RECEIVEDON: **April 13, 2016**

CONFORMANCE

PRECAST RIGID BRIDGE LAYOUT & DETAILS
 Drawing No. R-S22624-L01A
 REV 3

MILLER CONSTRUCTION, INC.
ROUTE 106 BRIDGE REPLACEMENT T.H. 61 (KENDALL ROAD)
WOODSTOCK, VT

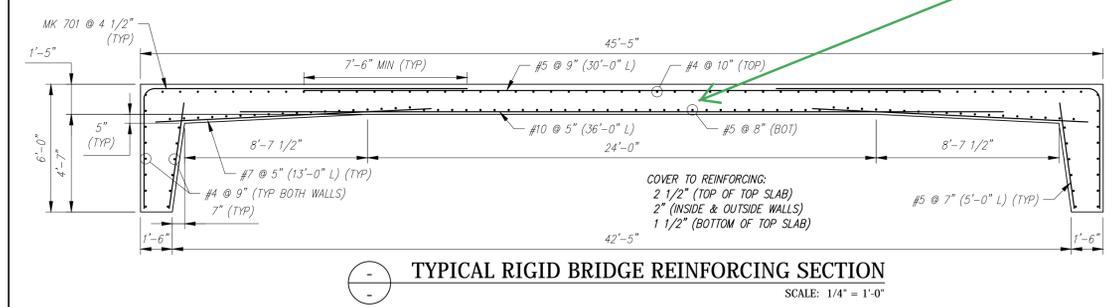
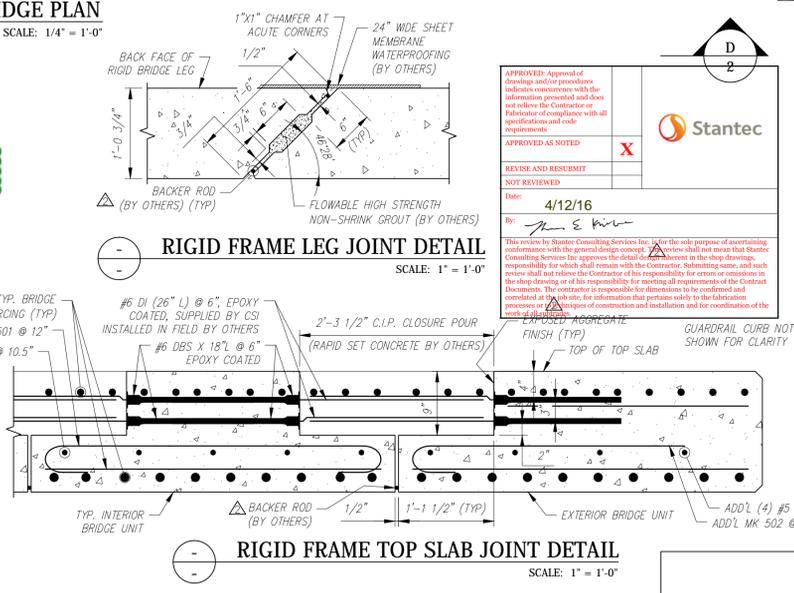
Rev.	Date	DESCRIPTION	By
10			
9			
8			
7			
6			
5			
4			
3	04/13/2016	ADDED STRIPPING STRENGTH AND CURING METHOD NOTES.	AK
2	04/08/2016	SEE REV2 TRIANGLES.	AK
1	03/23/2016	SEE REV1 TRIANGLES.	AK
Rev.	Date	DESCRIPTION	By
		REVISIONS

- FOR CURING METHOD, SEE SECTION 5.5 IN THE CSI QUALITY CONTROL MANUAL.
